# Errata Sheet

<b>Product Family:</b>	PLC Data Logging	<b>Date:</b>	August 2018
<b>Manual Number</b>	PC-DPLC-M		
<b>Revision and Date</b>	4th Edition, Rev. B; February 2014

## Change to Chapter 5. Ladder Logic; 5.1 WX/RX Commands

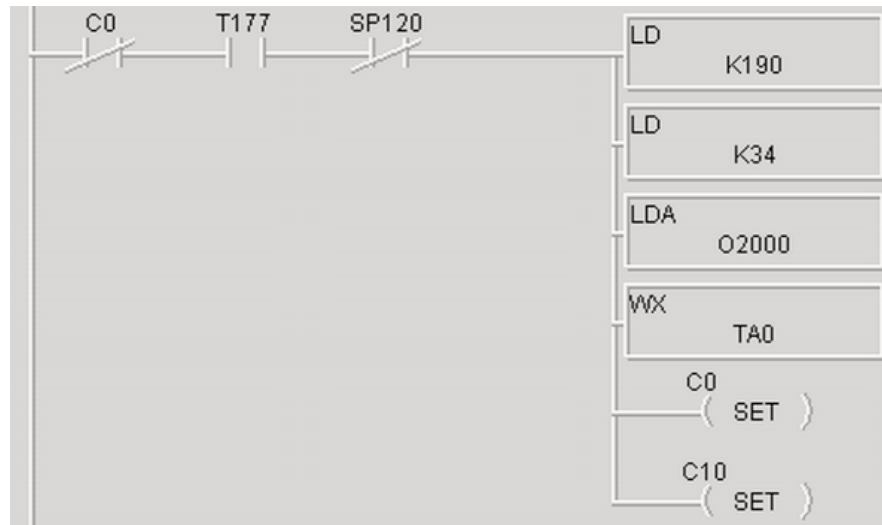
Step 1 on page 20 is incorrect: It should be:

"high" and "low" bytes are reversed below in step 1. See Errata Sheet

1. Load the address 90 (BCD) into the ~~high~~ <sup>low</sup> byte and the slot number of the ECOM module into the ~~low~~ <sup>high</sup> byte. Address 90 (BCD) is required for PLC-to-PC communications with DataWorx PLC.
2. Load the number of bytes to be transferred. This will be 32+ the number of data bytes (1 - 96). Thus, the total bytes transferred will be 33 - 128.
3. Load the address of the data block used to generate the packet. **This address must be specified in HEX.**
4. Insert the WX instruction.

*"1. Load the address 90 (BCD) into the low byte and the slot number of the ECOM module into the high byte. Address 90 (BCD) is required for PLC-to-PC communications with DataWorx PLC".*
